Subject: FCC Class II Permission change for FCC ID: 2ARRB-PIP1510CBU

This is to request a Class II permission change to our product name: Video Baby Monitor;
(FCC ID: 2ARRB-PIP1510CBU), the device is identical to the previously certified except for
the changes as below for details;

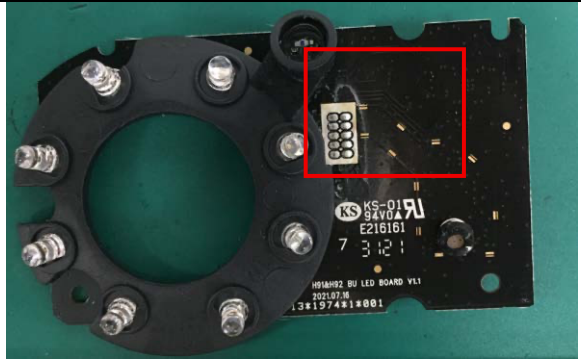
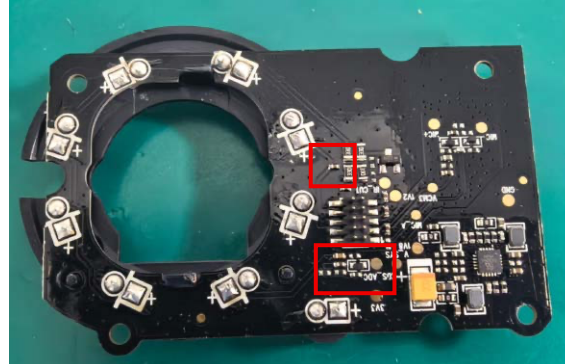
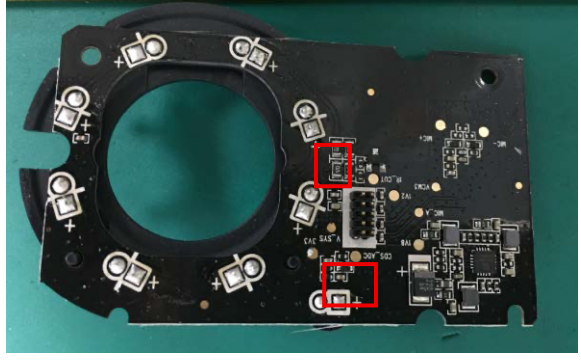
New Model	Old Model
1. Improve ESD (Guo Wei internal ESD requirements: 6kV for contact and 15kV for air), and add ESD tubes D522-526

2. Change the J5 socket to an SMD packaged socket, slightly adjust the placement of C32 and C49, and add D58(Guo Wei internal ESD requirements, contact 6kV, air 15kV).

3. The socket plug-in was changed to a surface mount component. The positions of the peripheral components were slightly adjusted. The directions of the keys, rotation, and peripheral parts were also slightly adjusted. Nothing else changed
